Technical Bulletin

CS 43/44/45 Sockets Improved Quality Level

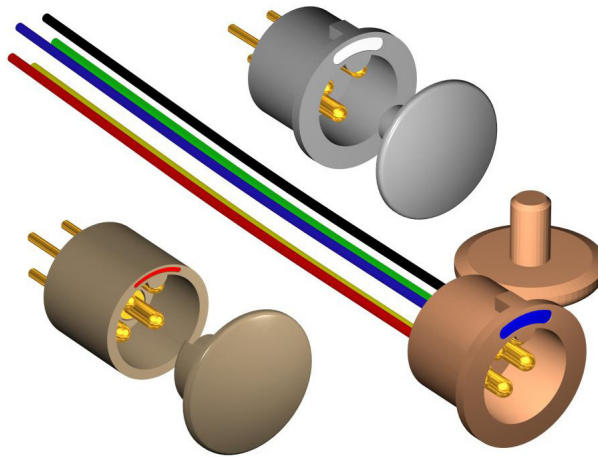
Sonion is pleased to announce that we have improved the mechanical properties and electrical performance as well as the production processing of our CS 43/44/45 Sockets with flexible insulated leads.

The CS 43/44/45 Sockets were as of December 1998 produced with insulated silver-plated copper leads instead of insulated silver leads.

Compared to the previous type of the CS 43/44/45 Sockets with flexible leads, the new type has the following features:

- Improved tensile strength
- Improved bending properties
- Same solderability properties
- Improved electrical performance
- Same color range of flexible leads
